APPLICATION FOR SUBMITTAL OF POST-APPROVAL DOCUMENT

School District/Owner: Yuba Community College District	DSA File Number: 58 C1
Project Name/School: Woodlland Community College	DSA Application Number 02 118286

see attached Addendum 2 for Narrative

drawing no.:
A220
drawing of

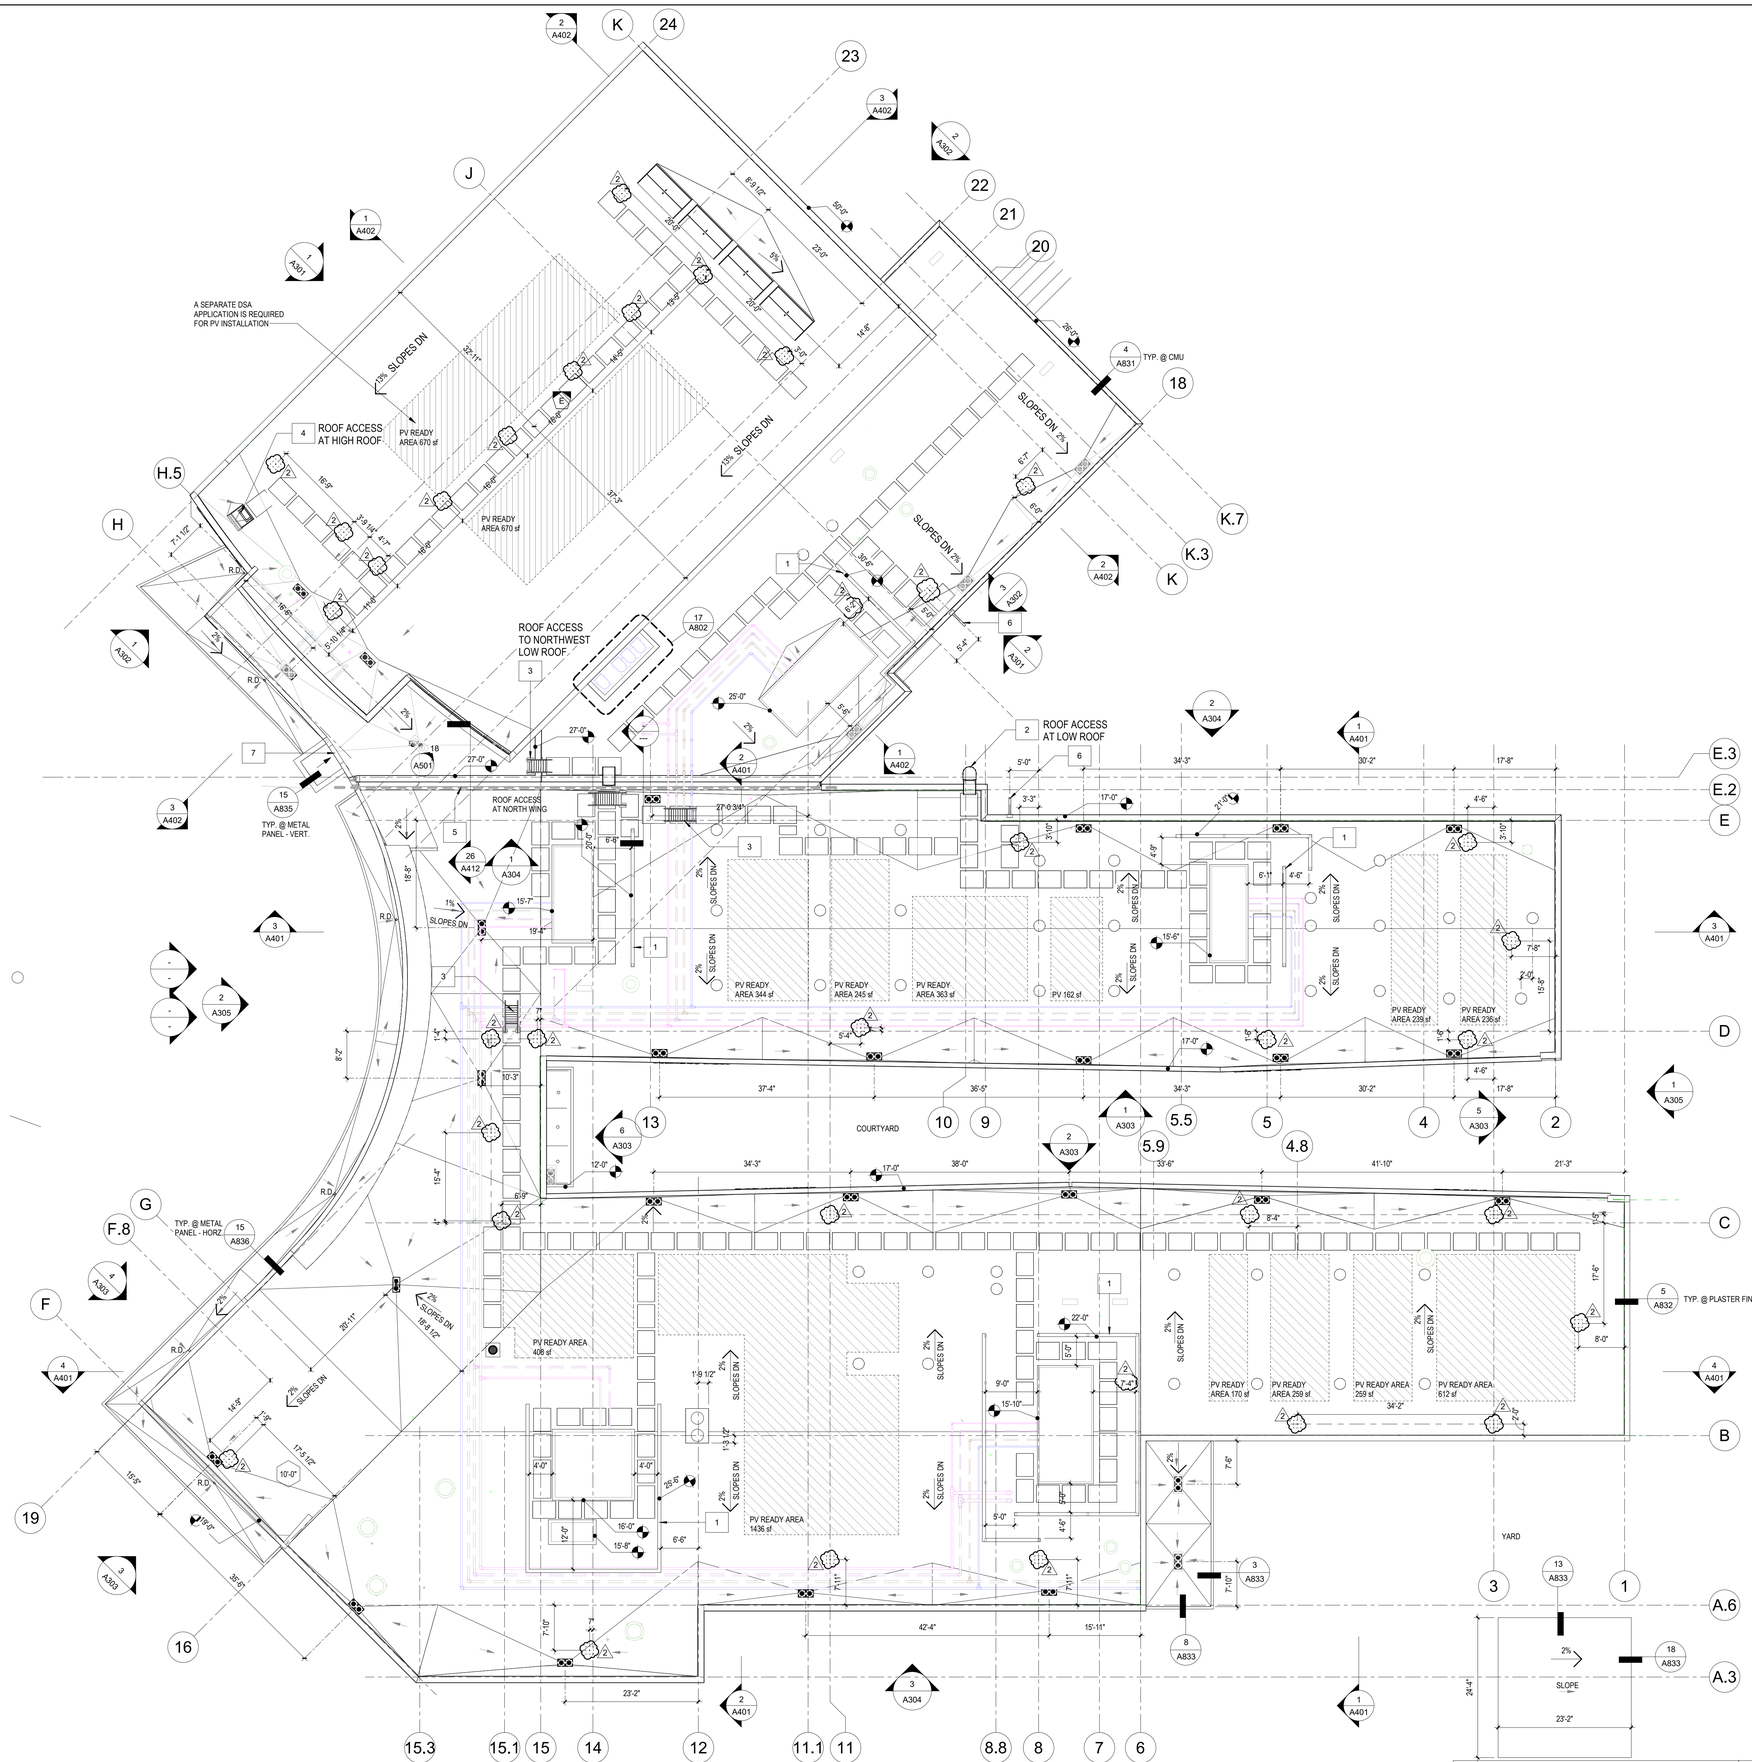
- **c. A220**
  - i. Update dimensions to align roof anchor points/ roof screens over steel structure
  - ii. Add additional note for Roof Anchor Point (Roof Legend)

drawing no.:
A221
drawing of

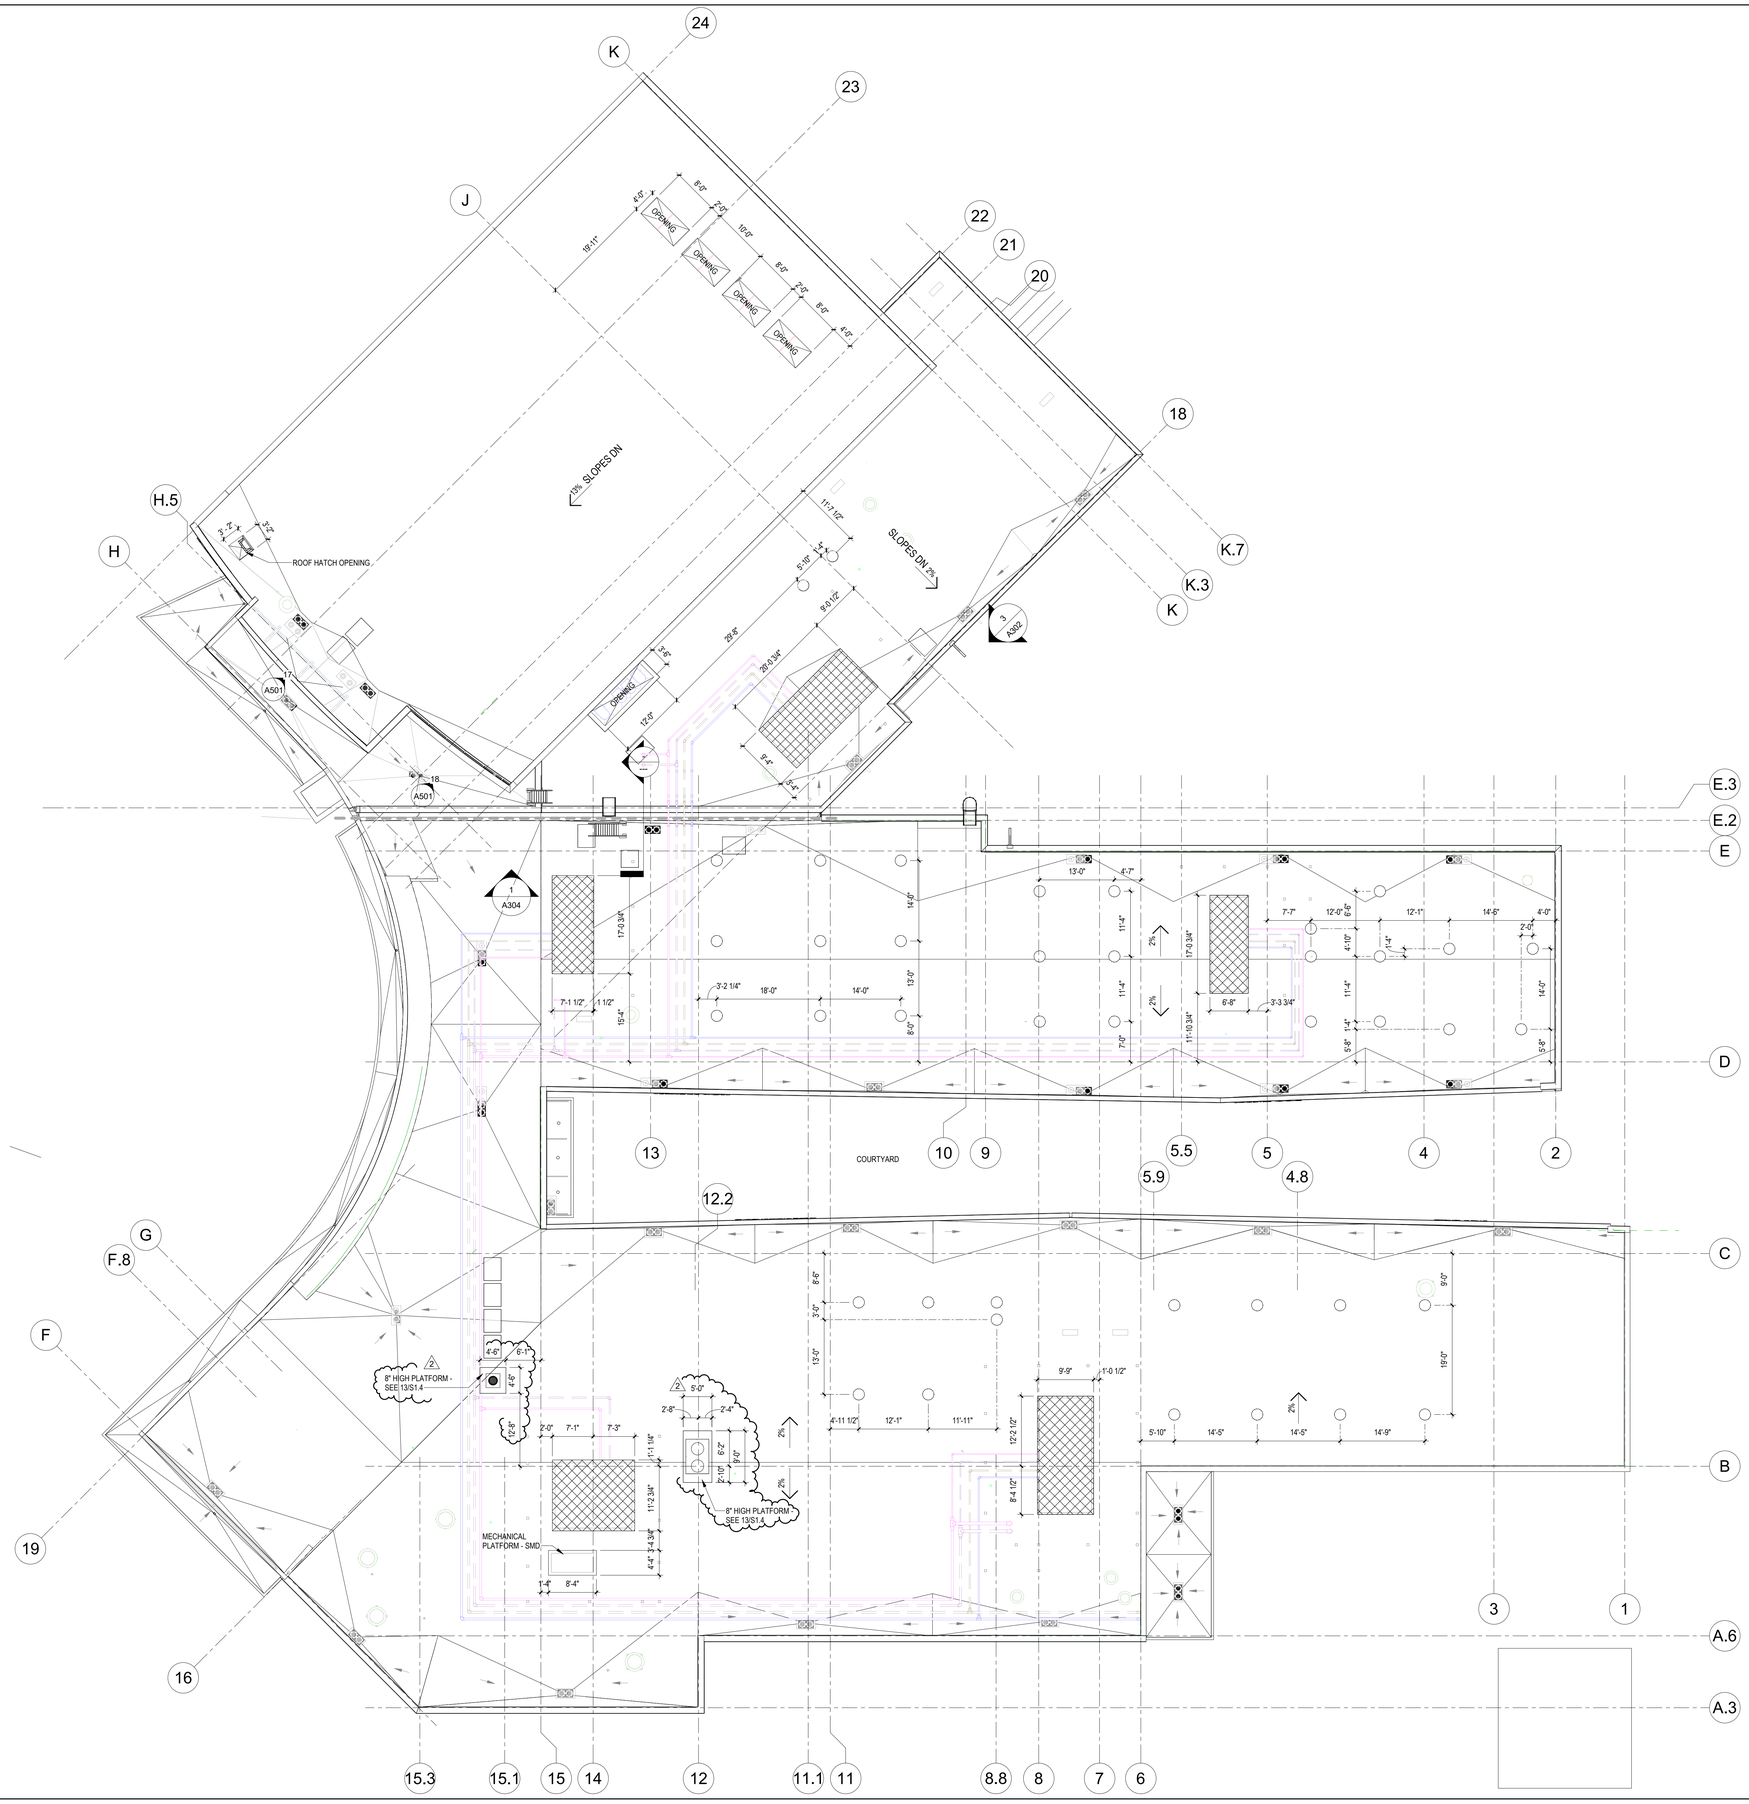
- **d. A221**
  - i. Locate mechanical platform
- **e. A241**
  - i. Provide soffit elevation at Lobby
- **f. A242**
  - i. Provide soffit elevation at Lobby

NORTH WING - E
SCALE : 1/8" = 1'-0"

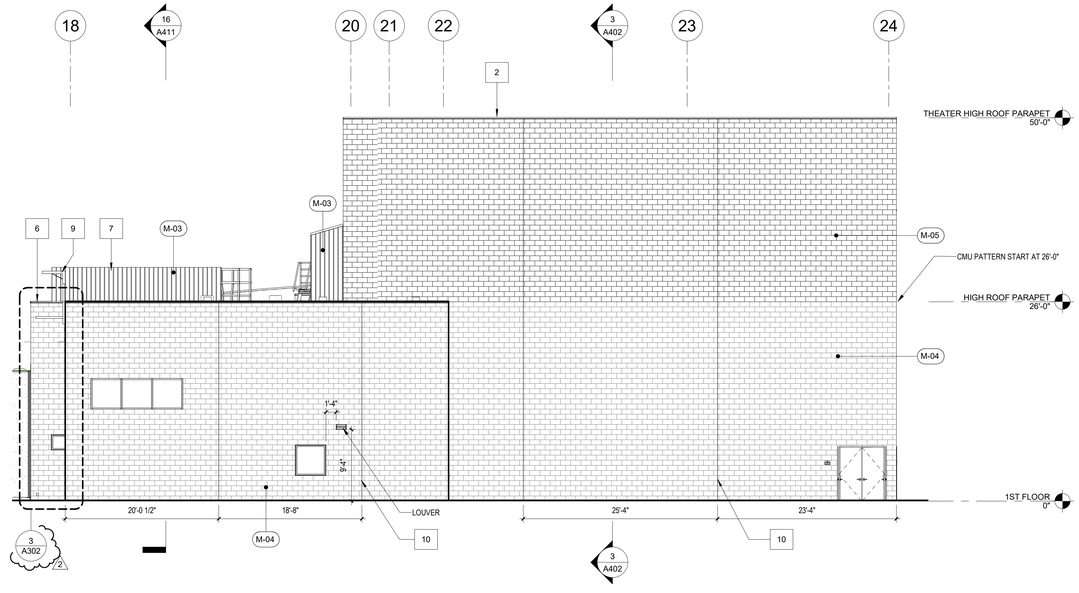
- **g. A302**
  - i. Detail 2 – added reference detail to detail 3/-
  - ii. Detail 3 – New North Wing – E Partial elevation
- **h. A411**
  - i. Detail 11- added reference details

ROOF WINCH BRACKET MOUNTING PLASTER 9

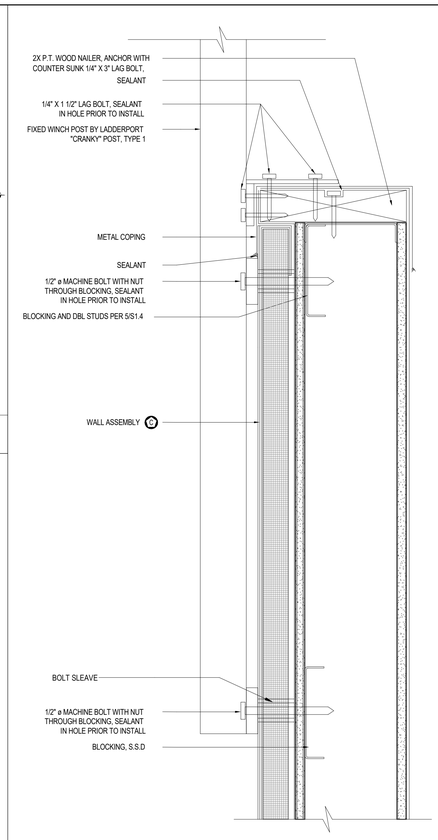
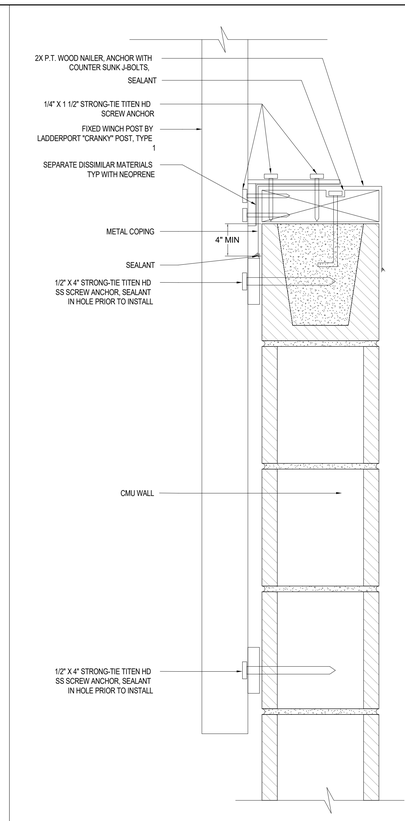
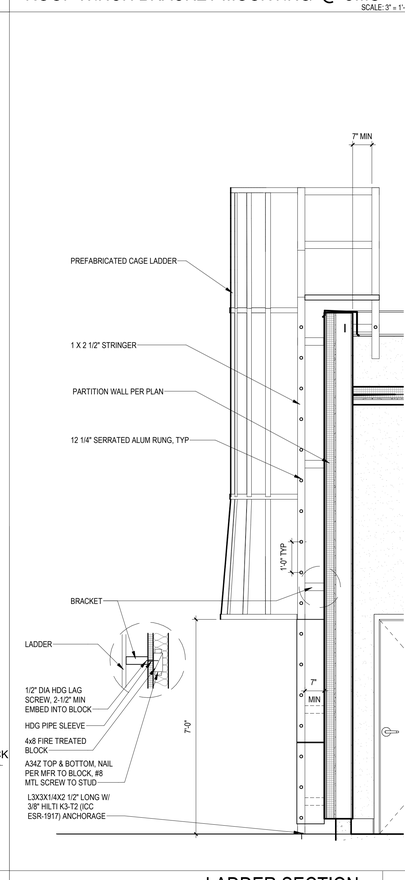
m. A850
   i. Detail 6 – locate water barrier inside of the seismic joint
   ii. Detail 9 – add counter flashing and/or GSM at roof bellows transition at plaster wall

drawing no.:
S3.2

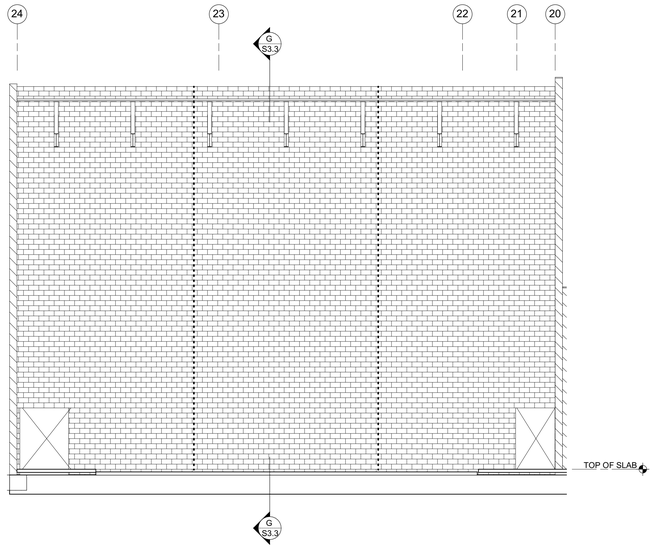
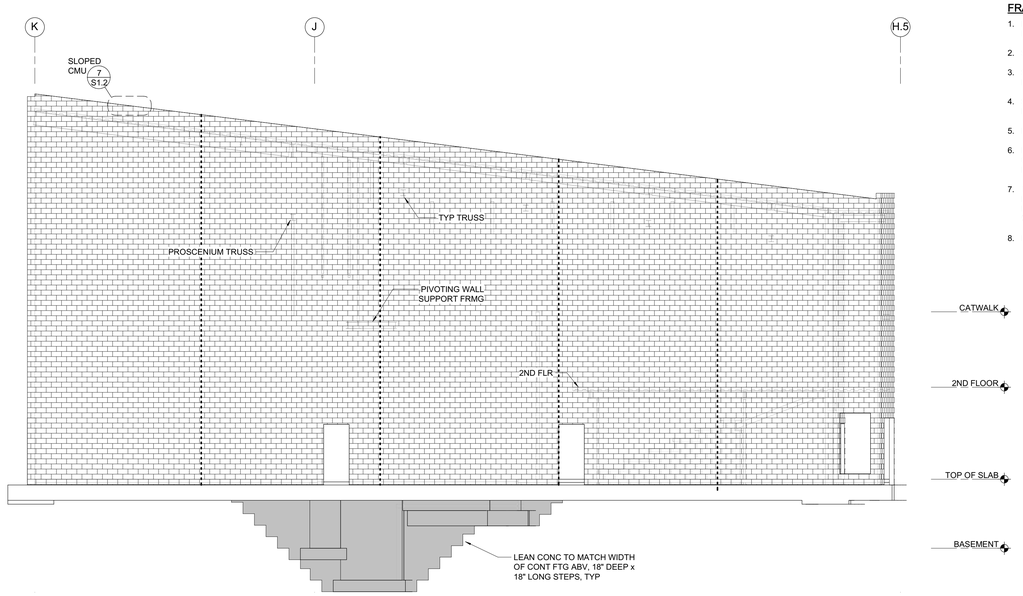
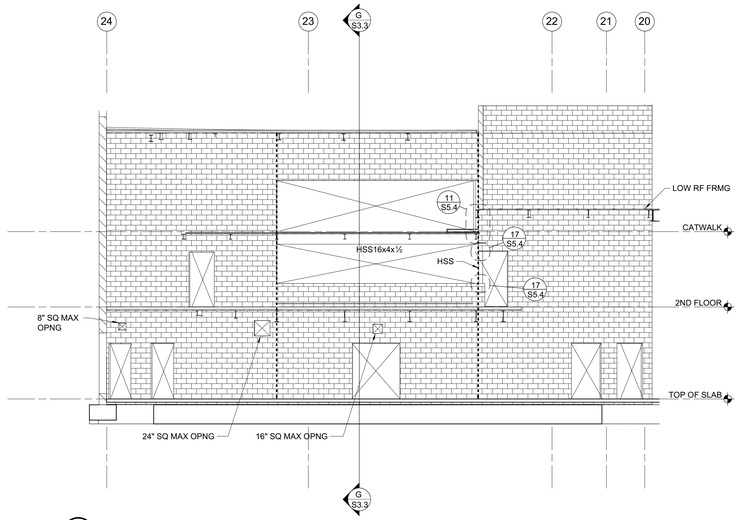
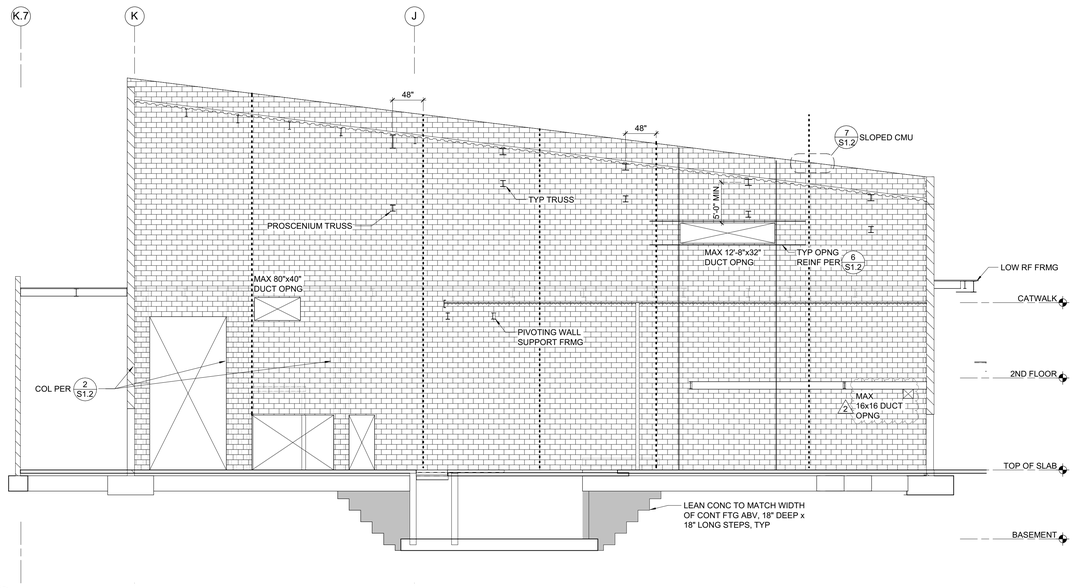
g. S-T2.1: Foundation Plan. Clarified to coordinate with Architectural drawings for CMU wall control joint locations.
h. S3.2: Elevations B & E. Updated extent of mechanical opening in CMU wall.
